Access Compliance Report Public Rights-of-Way (Curb Ramps)

Main Street: NEWPORT_AVE	Cross Street: CASTLEGATE_LN	Location: W
--------------------------	-----------------------------	-------------

ADA ID: RPRK211008132300	Ramp Type: Type 1 - Perpendicular Diagonal	Initial Pass/Fail: Fail	Overall Compliance: No	Severity Score: 2
--------------------------	--	-------------------------	------------------------	-------------------

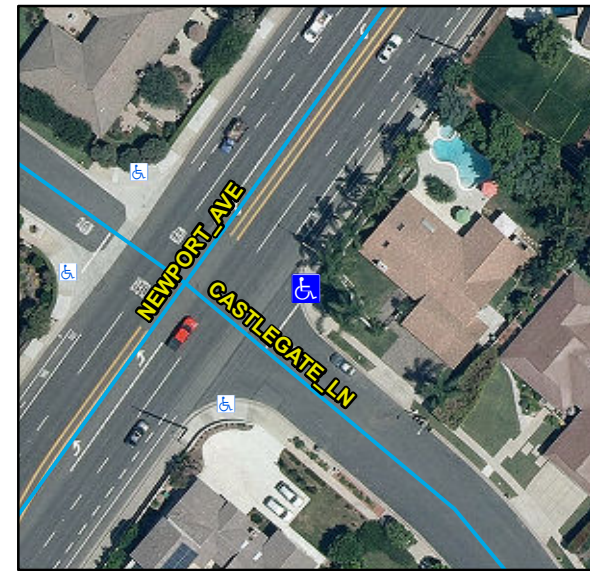
R304.2.2, R304.5.3, STD 1115

Remove & Replace Curb Ramp With Two New Directional Ramps or Equivalent.
